Foidel Creek Mine Inspection Report

Permit Number: C-1982-056 Mine Name: Foidel Creek Mine Operator: Twentymile Coal, LLC Operator Address: Ms Miranda Kawcak 29515 Routt County Road No. 27 Oak Creek, CO 80467 County: Routt Operation Type: Underground Permit Status: Active Ownership: Private

This was a partial inspection of the Foidel Creek Mine; DRMS Permit No. C-1982-056, operated by Twentymile Coal, LLC. (TC). This inspection was conducted by Hunter Ridley and Michael Cunningham with the Colorado Division of Reclamation, Mining, and Safety (Division). Kevin Copeland of TC accompanied the inspection. **Please address the Bold items below.**

Photo 3: View behind the stoker building. Three ditches are built behind this building and in front of the fence. Drainage from the stoker building reports to the pump house visible to the East in this photo.

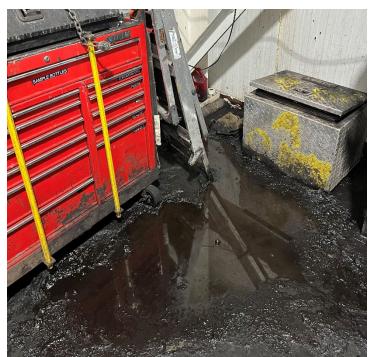
Surface drainage around the stocker coal truck loadout appears to be controlled. Drainage reports to a pump house directly connected to the stoker loadout building (Photo 3). Excess water from this building (Photo 4) which flows to sediment ponds is collected in a series of three ditches located behind the building (Photo 6). Straw bales have been placed on the upgradient side of the ditches to further aid in sediment control (Photo 5).

The drainage from this area and the road on either side of the loadout building should be reporting to existing ponds and the gradient should be maintained to ensure any runoff from the area or cleanup of the building is able
